Casey Fields South Employment & Devon Meadows PSP, DSS & Amendment C295case

Issued
31 March 2025

Executive Summary

The landowners of 1934 and 1884 South Gippsland Highway, Devon Meadows, Kardinia Developments Pty Ltd, make this submission to the Casey Fields South Employment and Devon Meadows Precinct Structure Plan (CFS&DM PSP), the Casey Fields South Employment and Devon Meadows Development Services Scheme (CFS&DM DSS) and Planning Scheme Amendment C295case.

Figure 1: Extract from PSP Plan 2: Place Based Plan (VPA 2025)

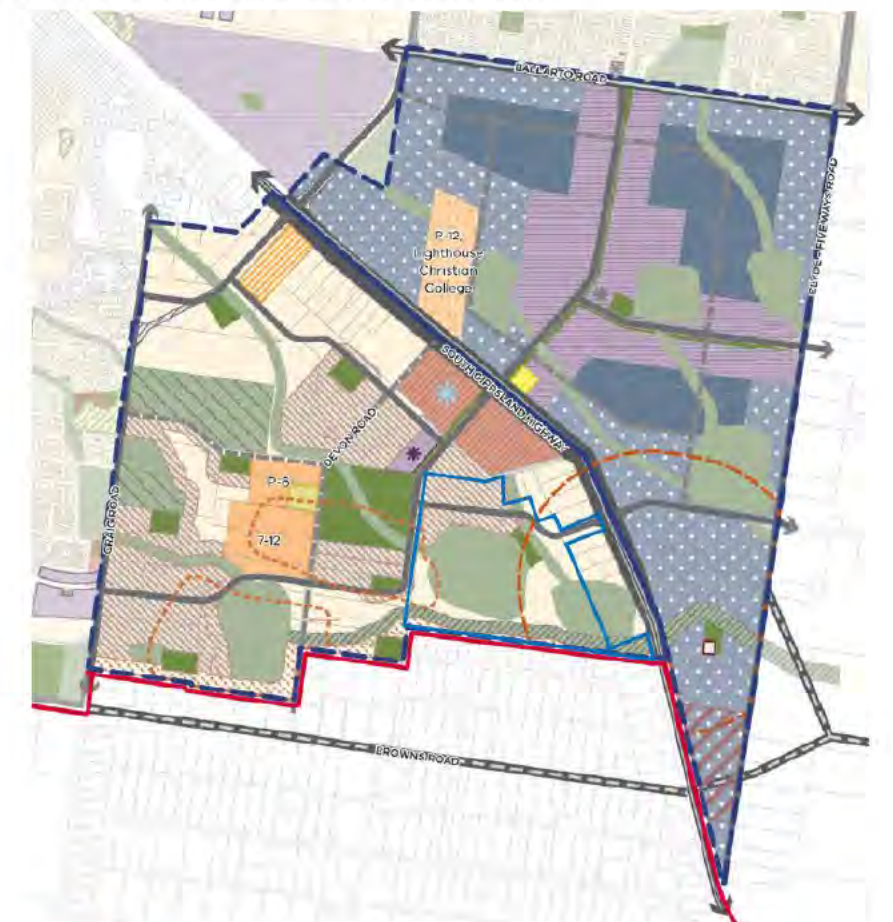
It is our submission that the areas designated as NRZ be removed from the NDA or the assets proposed on the subject land be better aligned to remove unusable NDA from the site.

The proposed location of the 40m wide PAO across the southern boundary of the site is an example of where unusable NDA has been created on the subject land. If the application of the PAO continues to be required over the subject land, then it is submitted that its alignment must not further burden the landowner with inefficiencies in land use.

The waterway located on the eastern half of the site is not supported. Flows coming through the pipe fall within Melbourne Water's criteria to support the construction of a pipe in this location. Further, the pipe facilitates flows from a catchment that is less than 60ha in area, meaning the maintenance responsibility will fall on Council.

Figure 7: Place Based Plan Review (Source: Beveridge Williams)

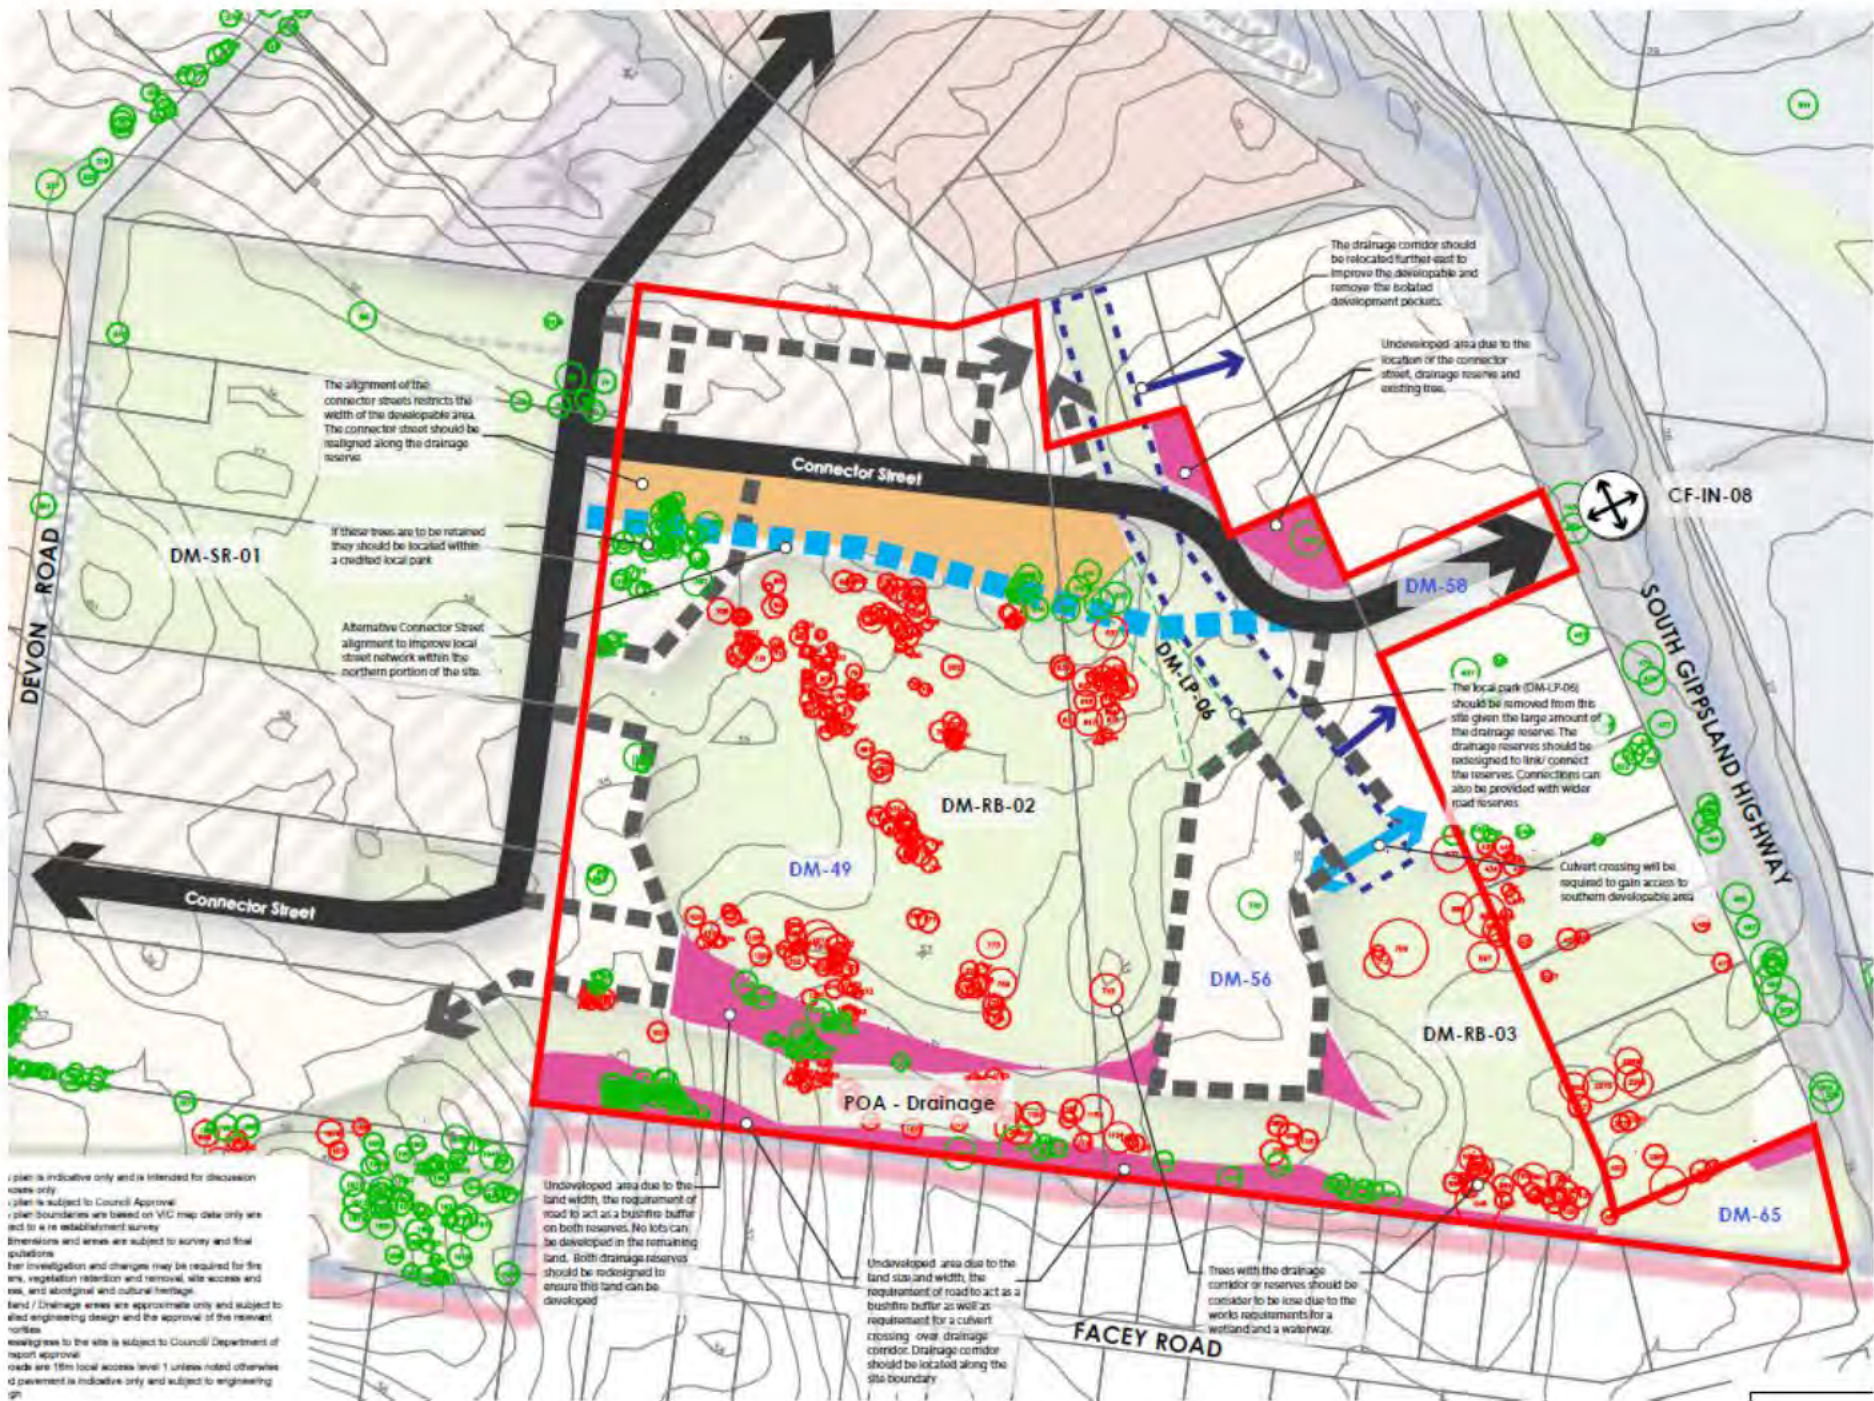
Figure 7 is based on the proposed Place Based Plan. The plan conceptually illustrates how the key land use elements nominated for the site have created an inefficient subdivision layout and challenge the efficient use of land to support a residential estate.

Significantly, much of the land designated as NDA is in fact unusable and cannot support residential development due to irregular lot dimensions, access limitations, bushfire setback requirements or lack of land area to support a dwelling. This area is highlighted in pink and comprises approximately 2.95Ha of land.

The area highlighted in orange is earmarked in the PSP as an increased area of amenity, however development of this land is restricted due to the alignment of the east-west connector street.

The PSP Review Plan identifies the trees nominated for retention but highlights in red the trees that will need to be removed to accommodate the proposed drainage assets on the site.

The plan also identifies the location of trees to be retained, with the NDA (located in adjacent to the north-west corner of DM-RB-02). It is likely that a substantial number of these trees will need to be removed to facilitate residential development, in which case they should be removed from PSP Plan 13 or, they will be retained which removes additional land from the overall lot yield.

The PSP Land Use Budget identifies a total NDA of 15.57HA, this PSP Review Plan demonstrates that the real NDA is actually 12.62Ha, or 34% of the total site area.

The Plan review demonstrates that additional culverts will be required to facilitate access to an island land parcel that is located betweenDM-RB-02 and DM-RB-03. This outcome adds further expense the CFS&DM DSS.

Figure 8: Refined PSP Place Based Plan (Source: Beveridge Williams)

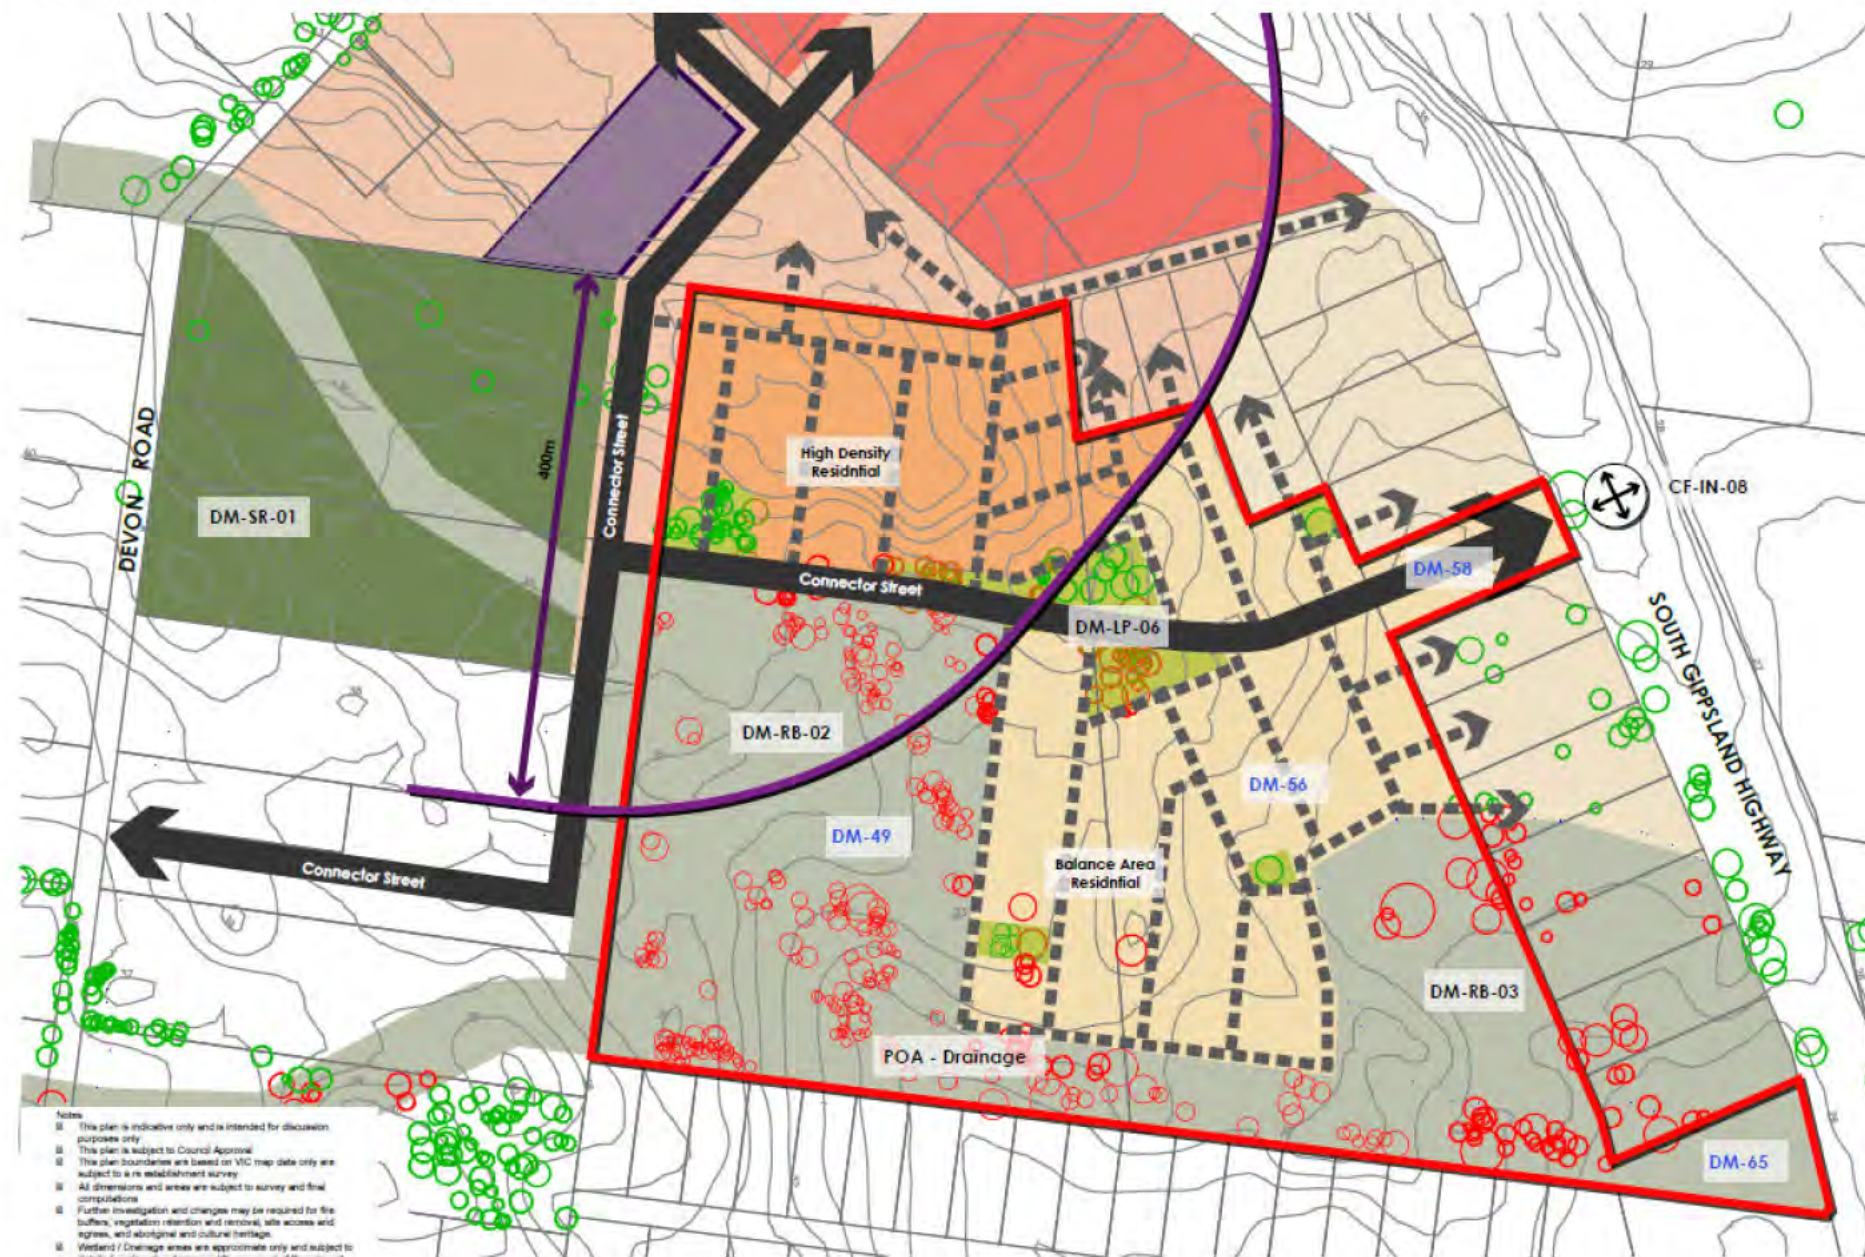
The revised Concept Plan demonstrates that the realignment of the assets on site could increase the NDA to approximately 19.41Ha. It is submitted that this outcome benefits the developer and also more substantially contributes to the achievement the Victorian government's housing targets.

- The re-alignment and location of infrastructure assets (both road and drainage) remove removal of unusable NDA from the site.
- High density (increase amenity area) can be appropriately delivered in proximity to within the 400m walkable catchment of the local convenience centre and the proposed schools.

- The balance area can be efficiently designed to facilitate appropriately orientated and dimensioned lots.
- The PAO is relocated to adjoin the Urban Growth Boundary and provides a secondary function as a green amenity break to the existing residents located on the north side of Facey Road.

- The removal of the north-south aligned waterway balance residential area supports a more efficient and functional subdivision layout. The alignment removes the need for a culvert crossing that would otherwise be required to access the 'island' which is located between DM-RB-02, DM-RB-03 and the PAO.

- If the removal of the north-south aligned waterway cannot be agreed upon, it is submitted that the waterway should be located to adjoin the eastern boundary of the site to support efficient land use and to maximise the development potential.

Figure 9: Preferred PSP Land Use Plan (Source: Beveridge Williams)

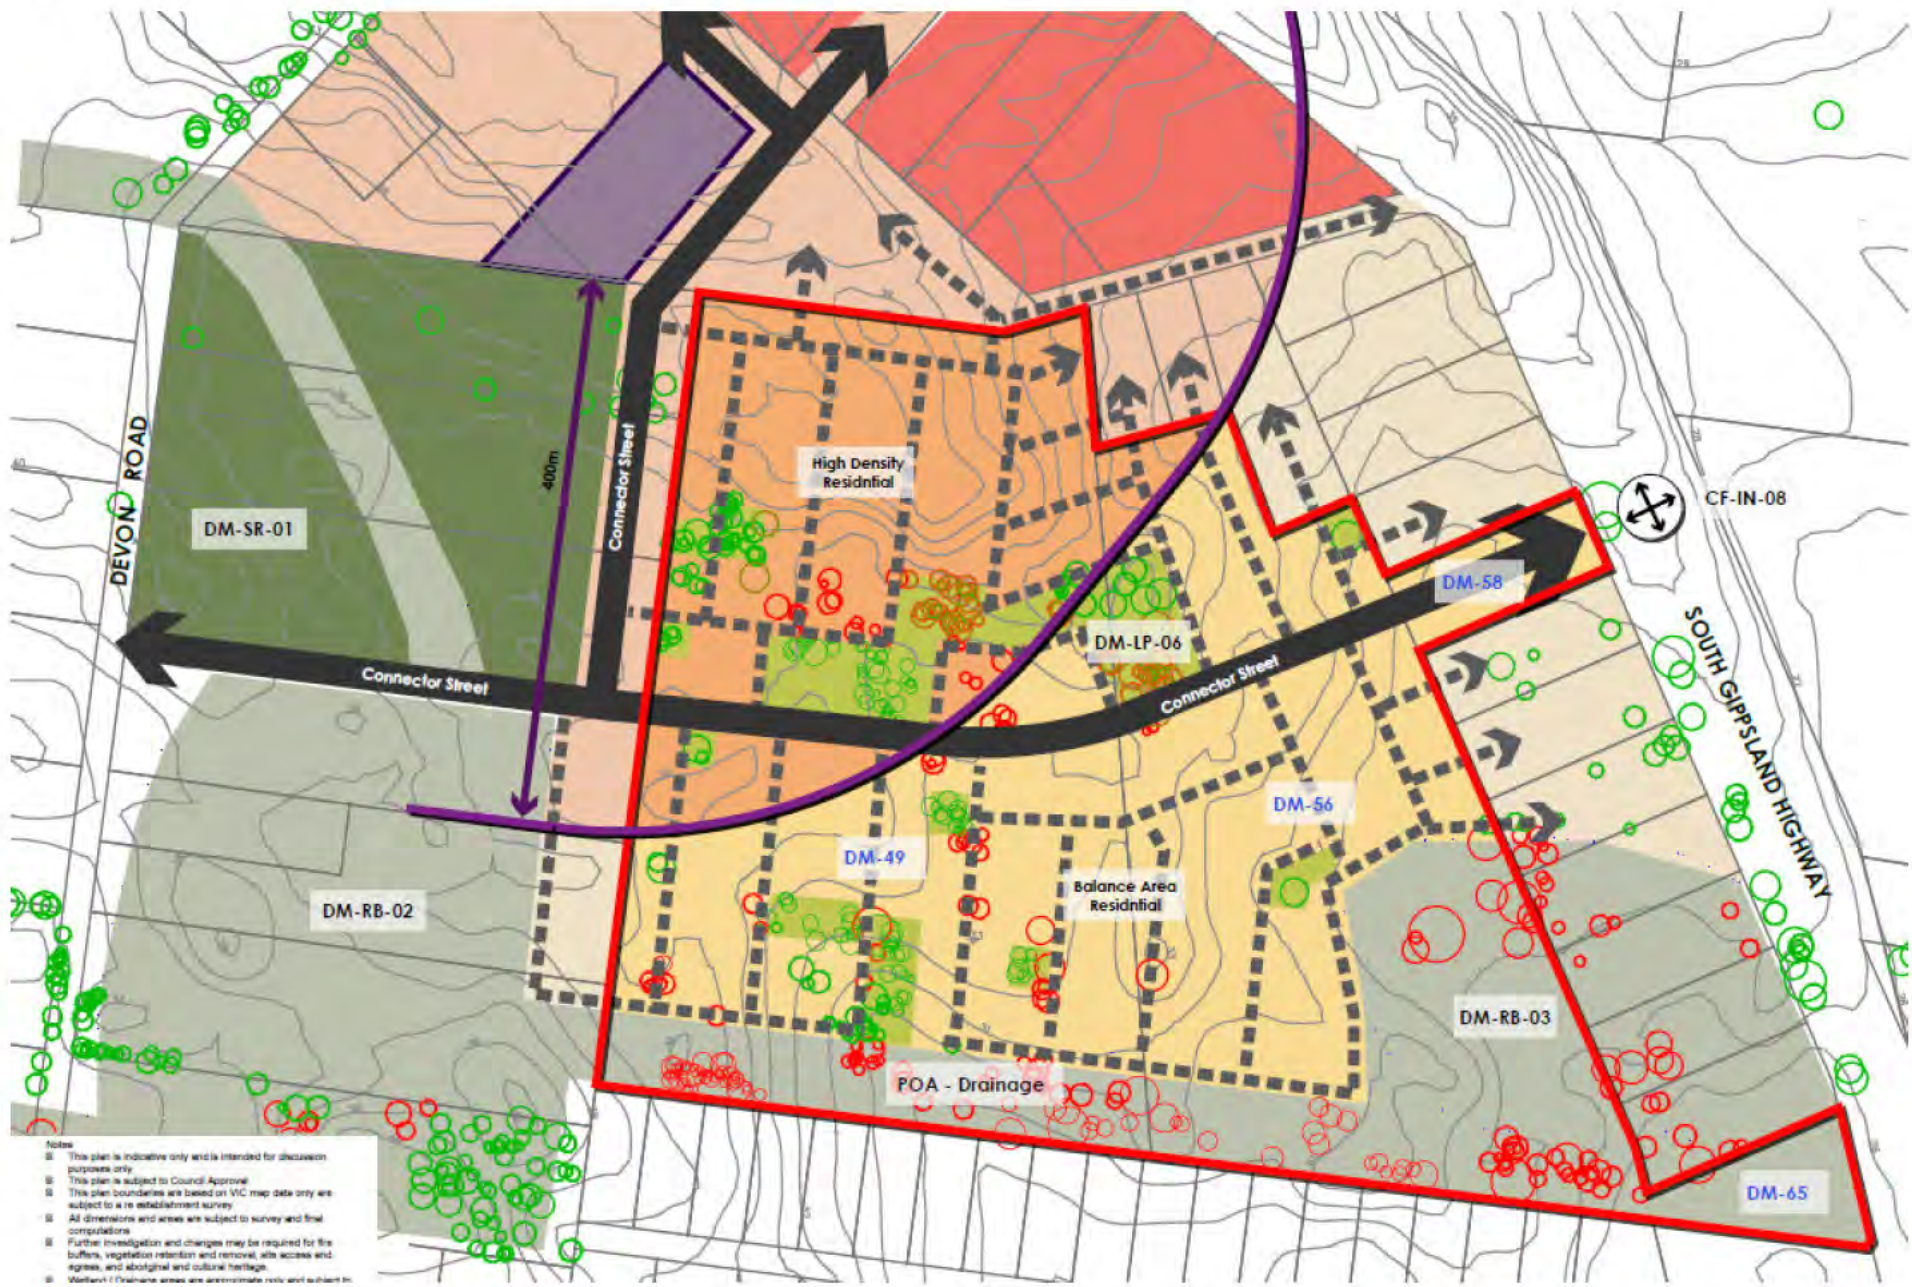
Similar to the Refined Place Based Plan proposal this Preferred Land Use Plan consolidates and realigns assets to reduce construction costs to the DSS and ongoing maintenance costs to Casey City Council. The plan limits unusable pockets of NDA and reduces the unnecessary provision of infrastructure, including additional road infrastructure and culvert crossings.

- The PAO and DM-RB-03 continues to be shown on the site to support drainage for the broader Devon Meadows Precinct. These features will provide a physical separation to the rural residences located immediately south of the UGB.

The Preferred PSP Land Use Plan supports an NDA of 25.98 hectares. It is submitted that this outcome benefits the developer and also makes a more substantial contribution to achieving the Victorian government’s housing targets, beyond what the current Place Based Plan allows.

It is submitted that the proposed alternative drainage designs that seek the relocation or complete removal of DM-RB-02 from the subject land offer a more equitable distribution of critical infrastructure. The balanced distribution of essential infrastructure across the precinct could help mitigate issues related to development delays, increased costs due to temporary interim drainage solutions, and significantly, unaffordability for the end user.

Figure 11: Public Realm Plan (Extract from Draft CFS&DM PSP Plan 5)

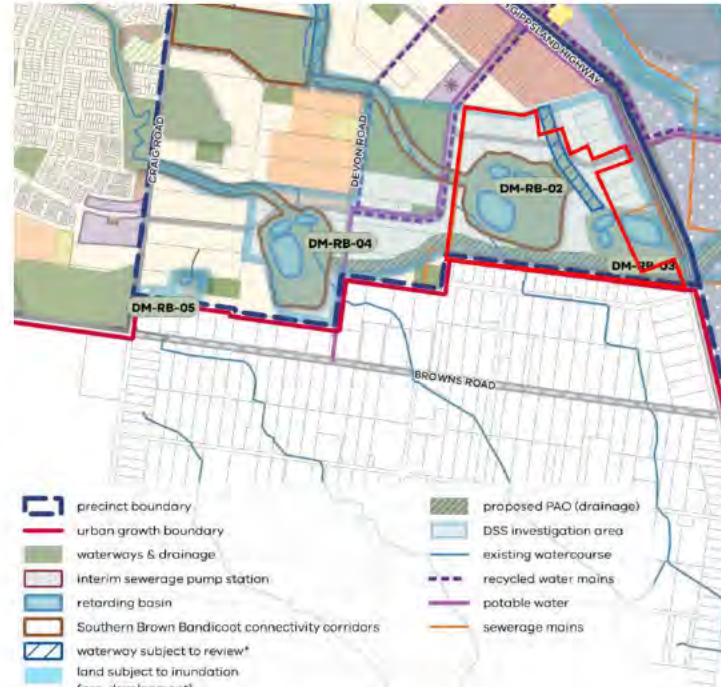
PSP Plan 5 – Public Realm and Plan 6 – Water nominates Southern Brown Bandicoot (SBB) connectivity corridor on the subject land.

It is submitted that due to the ongoing analysis relating to the location and size of drainage assets within the CFS&DM PSP and DSS, the location of SBB connections should be removed from the plan.

By identifying the location of SBB habitat on the PSP Plans, there is potential for the erroneous application of SBB habitat requirements as part of a future planning permit application, beyond what the final drainage requirements require. This is a distinct possibility for the subject land as multiple drainage consultants are looking to refine the draft DSS which in turn could have an impact on the drainage size, location or need for drainage assets on the property.

Acknowledging the requires for SBB connectivity through the precinct, it is submitted that PSP remove the SBB connectivity corridor from plans 5 and 6.

It is further submitted that modifications to PSP requirement R13 could facilitate the intent of Plans 5 and 6 as it relates to the SBB movement corridors:

Subdivision and development must provide for the delivery of Southern Brown Bandicoot corridors, including, safe passage culverts. DM-RB-02 and DM-RB-04, inclusive of their upstream waterways and safe passage culverts are to be established in accordance with Habitat Connectivity Design Standards for Southern Brown Bandicoot (DEECA 2023) to the satisfaction of the responsible authority.
